SEE BULLETIN Z-3 FOR FURTHER INFORMATION

PARTS INFORMATION:

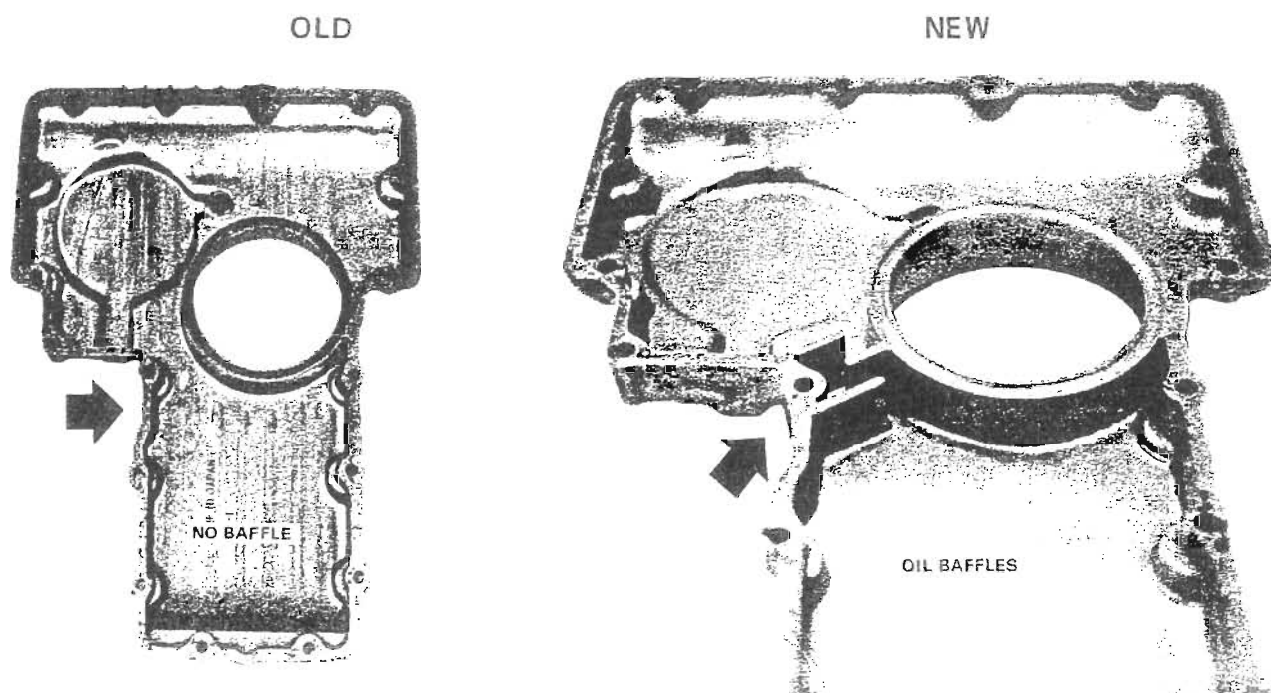
The Z1 oil pump is a positive displacement pump which requires a constant supply of oil at the pick-up. This means that if the oil flows away from the pick-up screen in the oil pan, the pump will draw air instead of oil, creating a block at the oil flow switch. Service Bulletin Z-3 described the solution to air blockage in the pump, that is, a small hole drilled in the oil flow switch plate to bleed the air out of the pump. This fix solves the air pocket problem once it has occurred, but does not prevent it from occurring. All Z1's after Z1E-02984 use the drilled switch.

The final improvement reduces oil starvation by the addition of a baffle in the oil pan. The baffle prevents the oil from flowing away from the pump screen on acceleration. This new pan is used on all Z1's after engine number Z1E-06431.

The new oil pan is interchangeable with the earlier model, and the part number remains unchanged (P/N 16110-002).
